Response for deadline 6 – matters arising from ISH3

Planning Inspectorate ref: EN020026

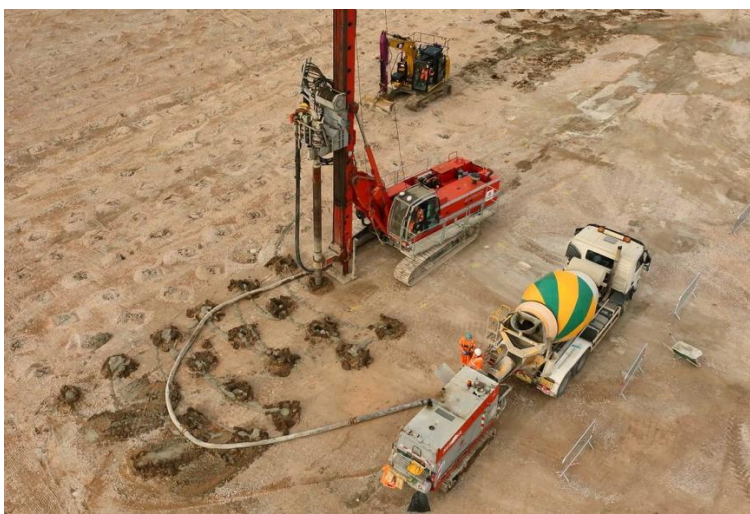
For example, this method was used at the nearby Discovery Park site in Sandwich to stabilise the ground for a fast-food restaurant. The project was carried out by Keller who stated on their website (Keller.co.uk) that the CMC (they referred to it as rigid inclusions) method was required because:

“The main challenge was to provide a solution through the very low strength strata of the Tidal Flat Deposits while avoiding the formation of a pathway for contamination to the aquifer below”.

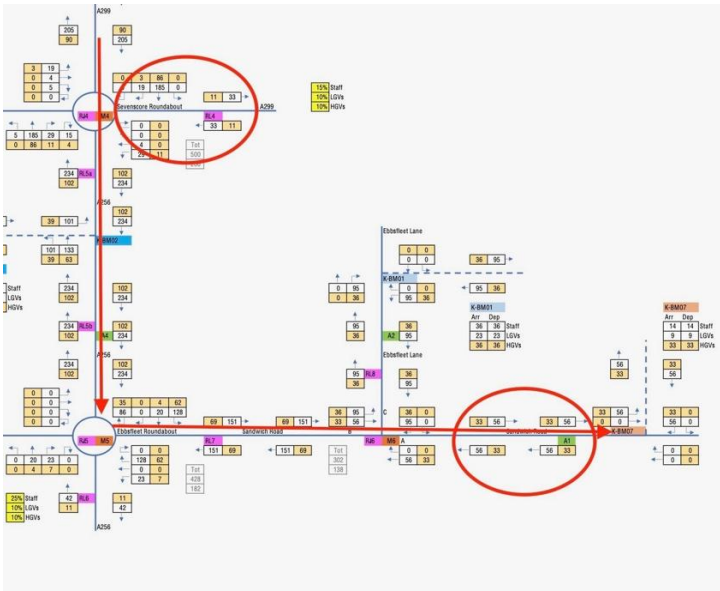
- a) In APP-181 Traffic Flow diagrams 12hr weekday (07.00-19.00) on the next page shows 90 HGVs (and 205 other vehicles) using the A253 whereas in APP-266 HGV routing map it shows HGVs using the A299 not the A253.

Is this a simple transcribing error or does the Applicant need to redo the Junction Modelling Capacity for K-RJ1?

- b) In APP-181 Traffic Flow diagrams 12hr weekday (07.00-19.00) it shows 33 HGVs continuing South at junction K-RJ4 onto the A256, left at K-RJ5 onto the Sandwich Rd, straight on at K-RJ6 until reaching K-BM07 (shown by the red arrow on both). The 33 HGVs then reverse that route from the compound at K-BM07 back to the A299.

In APP-181 Traffic Flow diagrams 12hr weekday (07.00-19.00) it shows 11 HGVs turning left at K-RJ4 (circled top left).

It is not clear to me why the 33 HGVs don't do the same onto the dual carriageway (as shown by the blue arrow on the right-hand map) and turn right at the next roundabout to reach K-BM07? This is a much shorter route, on better roads and avoids passing receptors on the Sandwich Road.
